SUBJECT: Forwards June 1983 semimonthly open item report.

SWEC JUNE SEMIMONTHLY REPORT

OPEN ITEM REPORT

File No. 8065

FIGURE 3. TRAVELING JET FROM BREAK 12 ON LINE 24 IMPINGING ON SUPPORTS FOR LINE 63.
AREA "F"

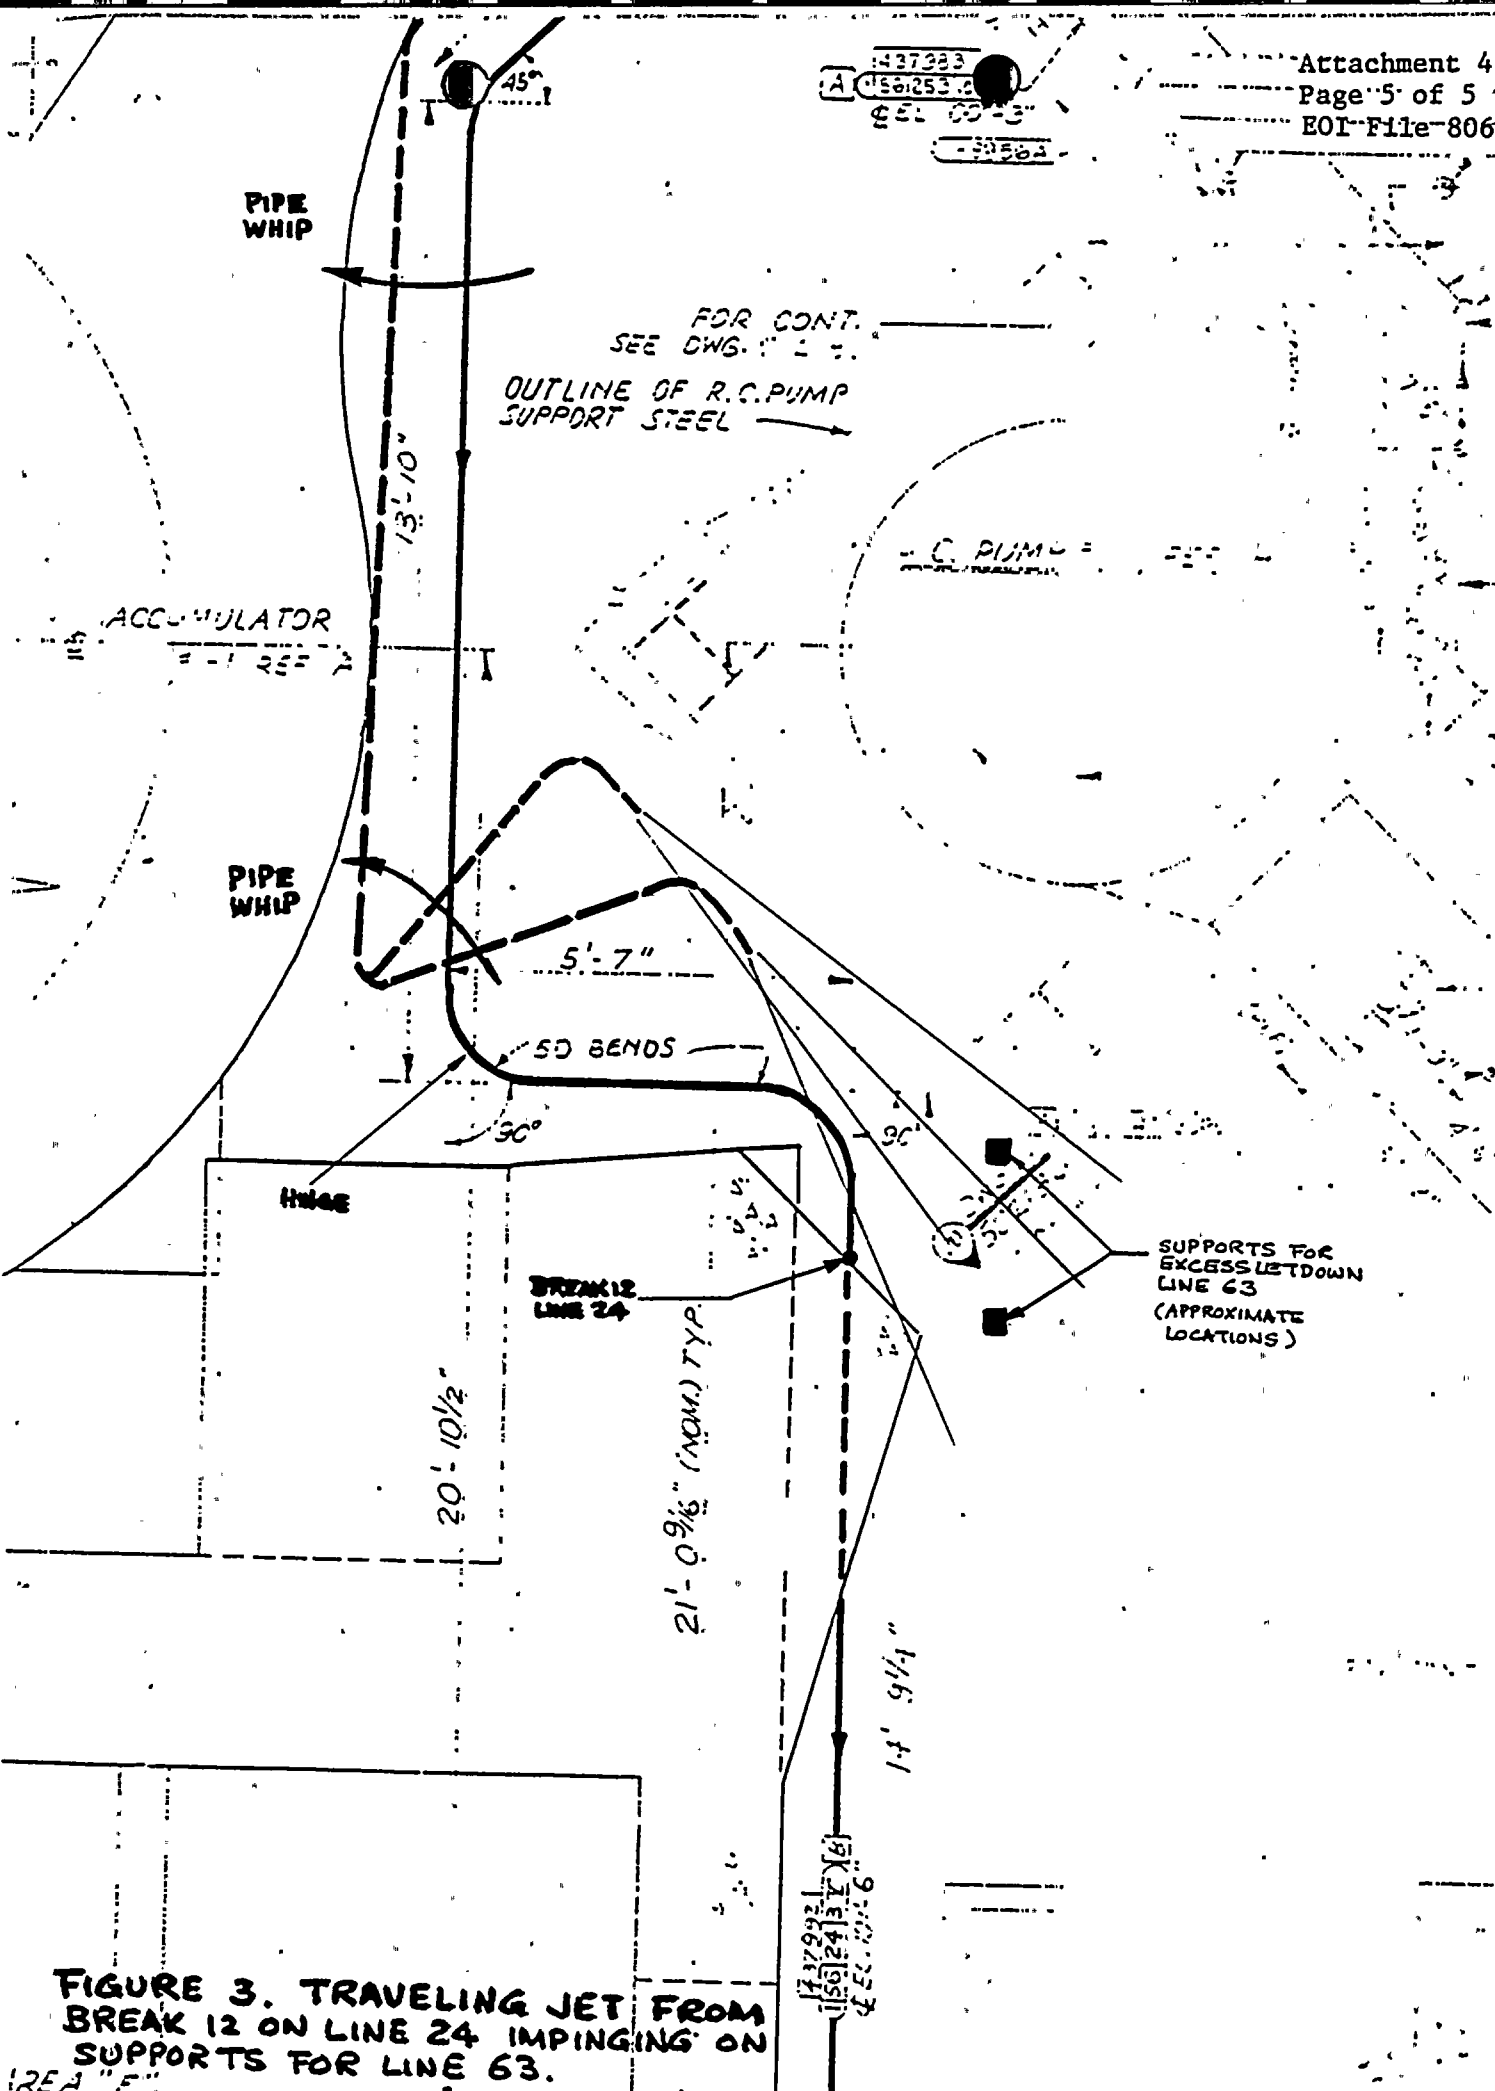
A pipe rupture on letdown line 24 at break location 12 (see Figure 1) results in a traveling jet. The traveling jet sweeps horizontally and impinges upon two of the vertical supports for the excess letdown line 63 (see Figures 2&3).

A safety evaluation should be conducted to determine if Excess Letdown line 63 is essential for reactor shutdown under the conditions associated with the postulated rupture of Letdown line 24, and to assure compliance with licensing commitments in FSAR Section 3.6.
